GEOTECHNICAL REVIEW & GLOBAL STABILITY ASSESSMENT:

Proposed Water Storage Basin & Biobasins, Interim Batters, Creek
Crossing Road Embankments and Bulk Earthwork Embankments

Various locations within Precinct 5, 6, 8 and 13

PG-5335-I

FIGURE 1 – Section 1: P6 Bio-basin Embankment

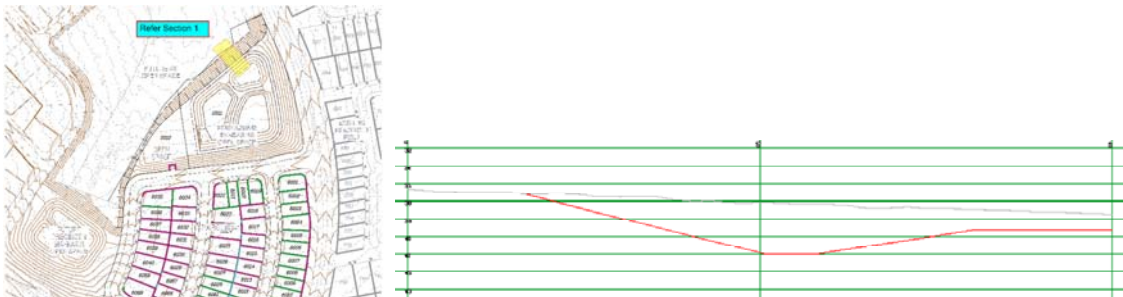
Section	Phreatic Conditions	FOS for Proposed Batter	Comment
P6 Bio-basin embankment	Construction	>1.5	Silty Sand must be removed from under embankment to expose underlying natural very stiff or better clay as per Section 4.5 of this report to achieve required FOS
	Elevated	<1.3	
P5 MIBA South Interim Batter – Waterford Tamborine Rd	Construction	<1.5	Embankment must be flattened back to no steeper than 26° as per Section 4.5 of this Report to achieve required FOS
	Elevated	<1.3	
P8 Lot 8526 Interim Batter – Pine Forest Way	Construction	>1.5	Embankment must be flattened back to no steeper than 45° as per Section 4.5 of this Report to achieve required FOS
	Elevated	<1.3	
P8 Stage 829 Basin South	Construction	>1.5	Achieves required FOS as per Section 4.5 of this Report
	Elevated	>1.3	
P8 Stage 827 Basin	Construction	>1.5	Achieves required FOS as per Section 4.5 of this Report
	Elevated	>1.3	
P8 Stage 828 Basin	Construction	>1.5	Achieves required FOS as per Section 4.5 of this Report

Embankment Section	Phreatic Conditions	Factor of Safety (FoS)
Section 1: P6 Bio-basin Embankment	Construction	2.52
	Elevated Phreatic Condition	1.44
Section 1A: P6 Bio-basin Embankment (Embedment into clay)	Construction	2.70
	Elevated Phreatic Condition	1.69

- All fill embankments must be keyed a minimum 0.5m depth into the underlying stiff (or stronger) natural clays. Where the clay embedment is not able to be practically achieved, consideration may be given to supporting the section of embankment on a crushed rock mattress, with details to be confirmed by Pacific Geotech.

FIGURE 2 – Section 2: P5 MIBA South Interim Batter – Waterford Tamborine Road

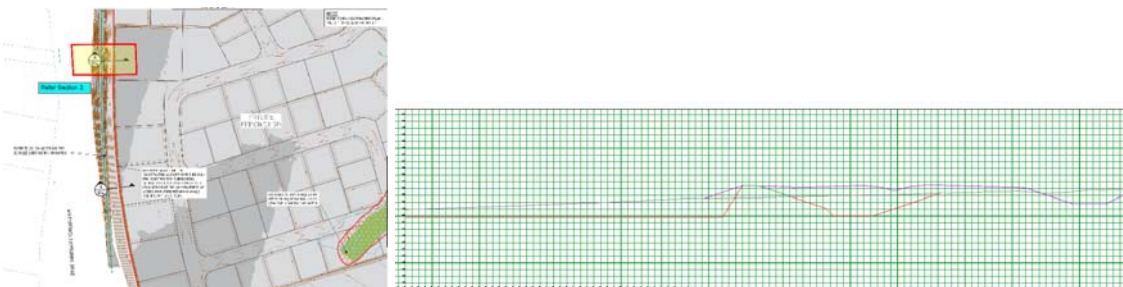
Embankment Section	Phreatic Conditions	Factor of Safety (FoS)
Section 2: P5 MIBA South Interim Batter – Waterford Tamborine Road	Construction	0.90
	Elevated Phreatic Condition	0.90
Section 2a: P5 MIBA South Interim Batter – Waterford Tamborine Road (45° Slope max.)	Construction	1.38
	Elevated Phreatic Condition	1.04
Section 2a: P5 MIBA South Interim Batter – Waterford Tamborine Road (26° Slope max.)	Construction	1.73
	Elevated Phreatic Condition	1.32
Section 3: P8 Lot 8526 Interim Batter – Pine Forest Way	Construction	1.52
	Elevated Phreatic Condition	1.12
Section 3a: P8 Lot 8526 Interim Batter – Pine Forest Way (45° Slope max.)	Construction	2.34
	Elevated Phreatic Condition	1.44
Section 4: P8 Stage 829 Basin South	Construction	2.73
	Elevated Phreatic Condition	1.65
Section 4: P8 Stage 829 Basin South (Embedment into clay)	Construction	2.12
	Elevated Phreatic Condition	3.09
Section 5: P8 Stage 827 Basin	Construction	2.76

- Maximum short term batter slopes of 45 degrees and maximum long term batter slopes of 26 degrees in on site soils are recommended for cut slopes up to 3m in height (subject to inspection at the time of excavation). For cut slopes greater than 3m in height, a 1.5m wide horizontal bench should be incorporated mid height and every 3m elevation, if the above maximum batter slopes are adopted.

FIGURE 7 – Section 7: P8 Stage 823 Culvert/ Creek Crossing

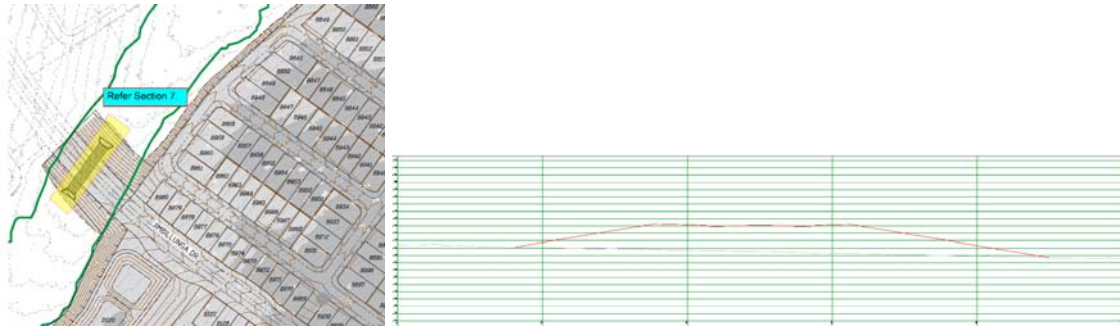
Elevated	>1.3	
P8 Stage 823 Culvert Crossing	Construction	>1.5	Achieves required FOS as per Section 4.5 of this Report
	Elevated	>1.3

Elevated Phreatic Condition	1.63
Section 6: P8 Stage 828 Basin	Construction	2.75
	Elevated Phreatic Condition	1.70
Section 7: P8 Stage 823 Culvert Crossing	Construction	3.68
	Elevated Phreatic Condition	2.54
Section 7: P8 Stage 823 Culvert Crossing (1.2m min. Rock Mattress)	Construction	4.04
	Elevated Phreatic Condition	2.64
Section 8: P8 Stage 829 Basin North	Construction	2.57
	Elevated Phreatic Condition	1.47
Section 8a: P8 Stage 829 Basin North (Embedment into clay)	Construction	2.76
	Elevated Phreatic Condition	1.71

Subject to inspection and testing of the stripped subgrade by Pacific Geotech to confirm the undrained shear strength, it is envisaged the crushed rock mattress would comprise the following - *NOTE: Rock mattress design may need to be altered at this point subject to results of the subgrade assessment by Pacific Geotech with an increase in thickness required if the shear strength is less than 50kPa.*

1. A lower layer of approved Geotextile/Geogrid (Tensar TX150 or Combigrid 60/60 or similar approved).
2. A minimum 1.2m thick layer of 75/150 crushed shot rock (or approved equivalent). The shot rock must be placed using end dumping techniques and compacted using the mechanical interlock method with a large excavator (>20t). The shot rock layer must pass a proof roll using a heavily loaded heavy rigid truck prior to placement of the next layer.
3. An optional additional layer of Bidim A39 (or similar approved) can be placed over the shot rock before placement of the MRTS Subtype 2.3 to assist in reducing potential loss of the road base gravel into the shot rock.
4. A 200mm thick layer of MRTS Subtype 2.3 shall be placed over the shot rock in maximum 200mm thick layers and compacted to 100% standard dry density ratio at +/- 2% of standard optimum moisture content.

FIGURE 8 – Section 8: P8 Stage 829 Basin North

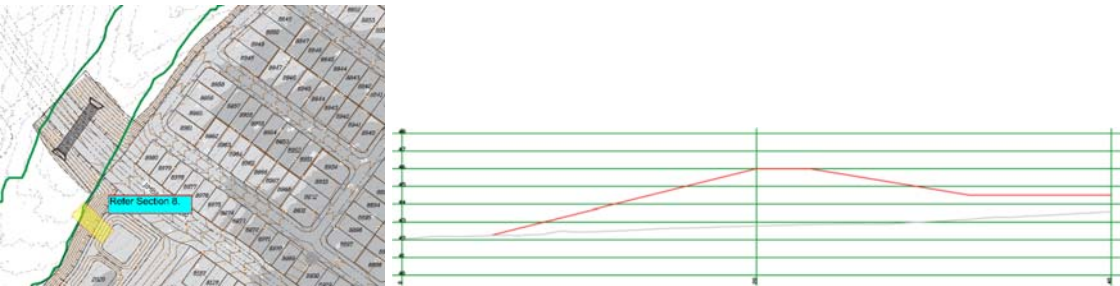
Section	Phreatic Conditions	FOS for Proposed Batter	Comment
P8 Stage 829 Basin North	Construction	>1.5	Embankment must be founded into the underlying natural clay as per Section 4.5 of this Report to achieve required FOS.
	Elevated	<1.3	
P8 Lot 8382 Interim Batter – Pine Forest Way	Construction	<1.5	Embankment must be battered back to no steeper than 26° as per Section 4.5 of this report to achieve required FOS
	Elevated	<1.3

FIGURE 9 – Section 9: P8 Lot 8382 Interim Batter – Pine Forest Way

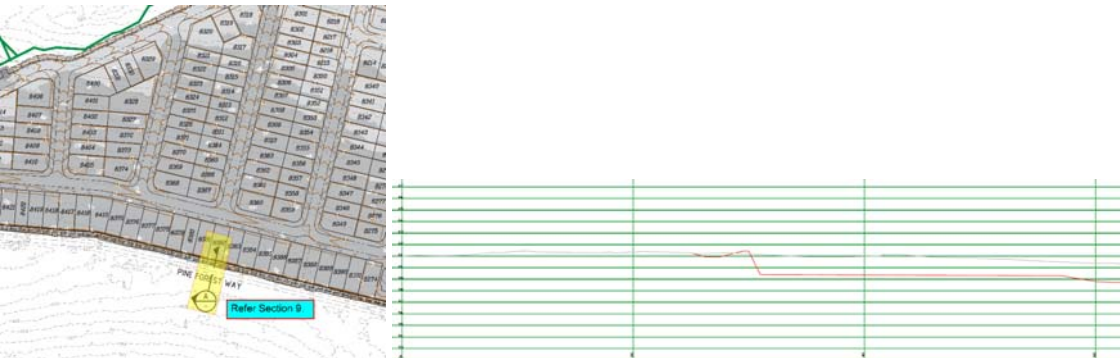
Embankment Section	Phreatic Conditions	Factor of Safety (FoS)
Section 9: P8 Lot 8382 Interim Batter – Pine Forest Way	Construction	1.33
	Elevated Phreatic Condition	0.93
Section 9a: P8 Lot 8382 Interim Batter – Pine Forest Way (45° Slope max.)	Construction	2.60
	Elevated Phreatic Condition	1.28
Section 9b: P8 Lot 8382 Interim Batter – Pine Forest Way (26° Slope max.)	Construction	2.60
	Elevated Phreatic Condition	1.83
